**NUMBER:** 08-016-15 REV. A

Poor Radio Reception

This bulletin involves replacing the satellite antenna if needed.

**Fig. 1 Antenna Mast and Base**

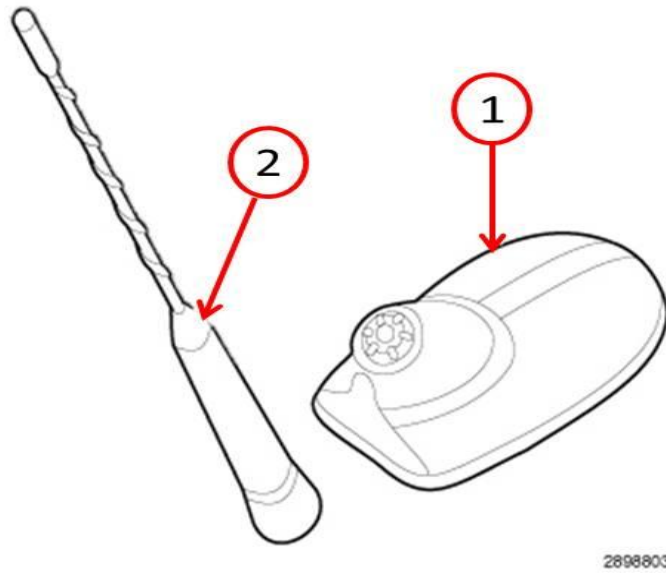
**NOTE: When replacing an antenna that has a screw on mast, the mast does not need to be replaced, see (Fig. 1)**
